**SUBJECT:** Savannah River Site's Responses to the Regulatory Comments on the Groundwater Mixing Zone Sampling Summary Report for the R-Area Reactor Seepage Basins/108-4R Overflow Basin Operable Unit 2023, SEMS Number: 25

**SRS Responses to SCDES Comments on the R-Area Reactor Seepage Basins/108-4R  
Overflow Basin Operable Unit (U) 2023, SEMS Number: 25, SRNS-J2000-2024-00461,  
Revision 0, Dated June 2024  
Savannah River Site, Aiken, South Carolina**

SRS Responses to USEPA Comments on the R-Area Reactor Seepage Basins/108-4R  
Overflow Basin Operable Unit (U) 2023, SEMS Number: 25, SRNS-J2000-2024-00461,  
Revision 0, Dated June 2024  
Savannah River Site, Aiken, South Carolina

Figure CR-1. Regional Groundwater Flow within the UAZ of the UTRA.

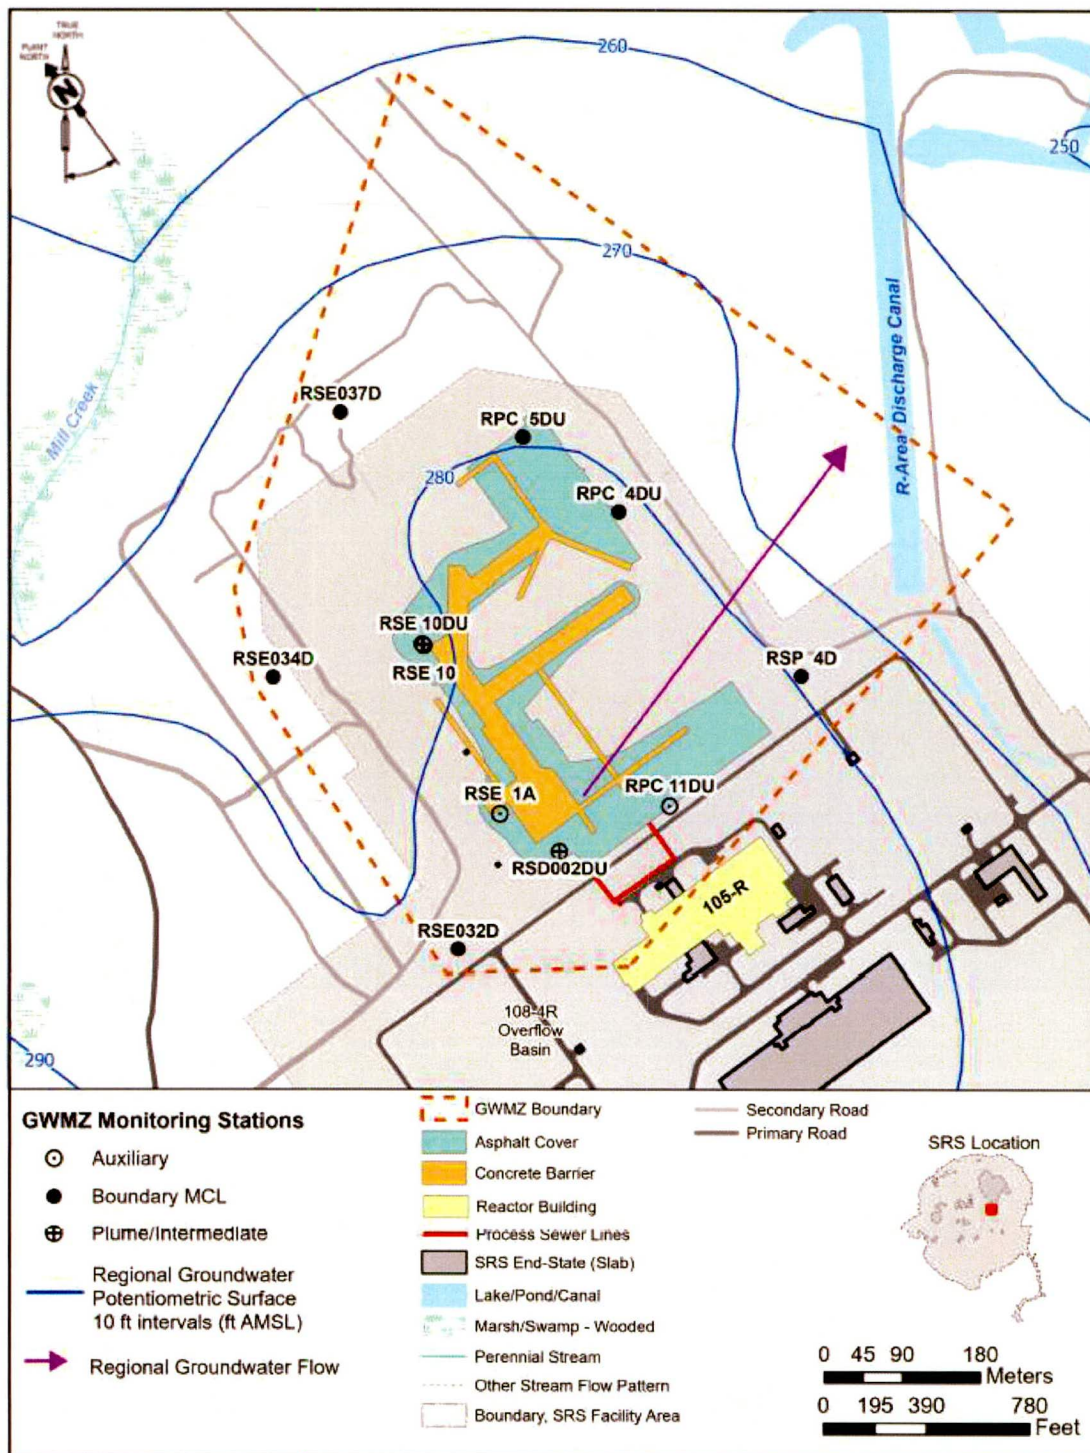
1. **Water Elevations, Page 2 of 10, Figure 2, 4Q23 Water Elevation of the A/AA Horizon in the UAZ, Page 7 and Figure 3, 4Q23 Water Elevation of the TZ in the UAZ, Page 8:**  
The text states that since the potentiometric heads in the A/AA horizon are generally about 2 feet to 8 feet higher than corresponding heads in the transmissive zone (TZ) no groundwater flow direction is drawn; however, while the groundwater elevations indicate that downward vertical gradient exists between A/AA and TZ, flow direction arrows should be drawn on the potentiometric surface contours of the A/AA in Figure 2 and the TZ, in Table 3. *Please revise the Report to include this information.*

**Response: Agree with Clarification.**

Due to the fact that localized groundwater flow is generally downward, use of regional groundwater data to determine flow direction in the UAZ will be used to generate a separate figure for the in future reports as shown in Figure CR-1 below.
